Office Action Summary	Application No. 10/537,068	Applicant(s) VAN HOUTUM, WIM	
	Examiner KABIR A. TIMORY	Art Unit 2611

DETAILED ACTION

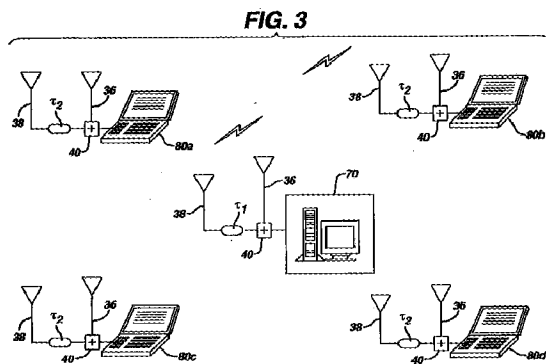
As shown in figure 1-9 Sugar et al. discloses a data communication system (see figure 1) comprising:

- a transmitter (212 in figure 2) having first and second transmitting antennae, (202, 204 in figure 2), the first antenna exhibiting a different delay than a signal path of the second antenna (par 0038, lines 1-14) ***(also, figure 1 shows that each STA has two receive antennas (Wrx1 and Wrx2) and two transmit antennas (Wtx1 and Wtx2) and the AP has four receive antennas and four transmit antennas, which according to paragraph 0038 “the signal will be sent from each antenna with a different delay spread”);*** and

- a receiver (214 in figure 2) having third and fourth (206 and 208 in figure 2) receiving antennae (par 0038, lines 1-14) ***(also, figure 1 shows that each STA has two receive antennas (Wrx1 and Wrx2) and two transmit antennas (Wtx1 and Wtx2) and the AP has four receive antennas and four transmit antennas, which according to paragraph 0038 “the signal will be sent from each antenna with a different delay spread”).***

In figure 6, Shoki et al illustrates:

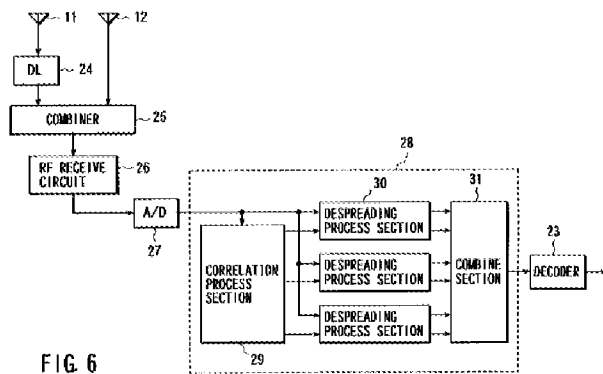
In figure 6 above, Shoki et al. clearly shows that receive antennas 11 and 12 receive communication signal and the signal which received by antenna 11 is delayed by the delay line 24 then the both delayed and non-delayed signals are combined by the combiner 25. This is the same operation and arrangement as shown figure 3 of the instant application. Therefore, the examiner makes his broadest reasonable interpretation in light of the specification that the third antenna (11 in figure 6) having a signal path exhibiting a different delay (24 in figure 6) than a signal path of the fourth antenna (12 in figure 6).

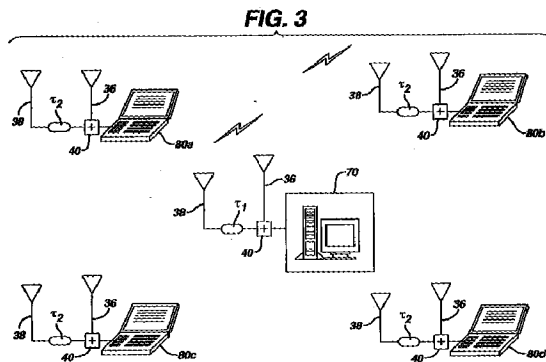
Sugar et al. disclose all of the subject matter as described above except for specifically teaching the signal path of the third transceiving antenna exhibiting a different delay than the signal path of the fourth transceiving antenna.

However, Shoki et al. in the same field of endeavor teach the signal path of the third transceiving antenna (11 in figure 6) exhibiting a different delay (24 in figure 6) than the signal path of the fourth transceiving antenna (12 in figure 6) (col 7, lines 36-67, col 8, lines 1-20). Although, Shoki et al. does not specifically teaches transceiving antennas, however it would have been obvious to one of ordinary skilled in the art to

In figure 6, Shoki et al illustrates:

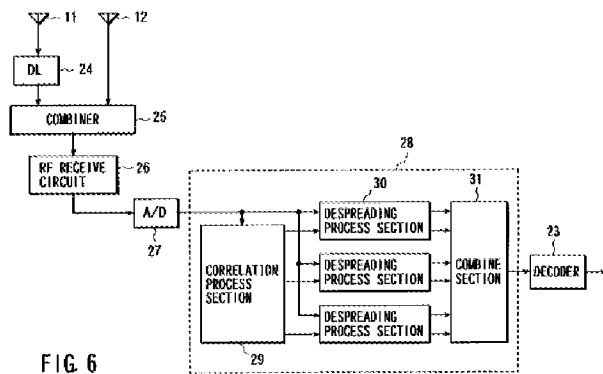
In figure 6 above, Shoki et al. clearly shows that receive antennas 11 and 12 receive communication signal and the signal which received by antenna 11 is delayed by the delay line 24 then the both delayed and non-delayed signals are combined by the combiner 25. This is the same operation and arrangement as shown figure 3 of the instant application. Therefore, the examiner makes his broadest reasonable interpretation in light of the specification that the third antenna (11 in figure 6) having a signal path exhibiting a different delay (24 in figure 6) than a signal path of the fourth antenna (12 in figure 6).
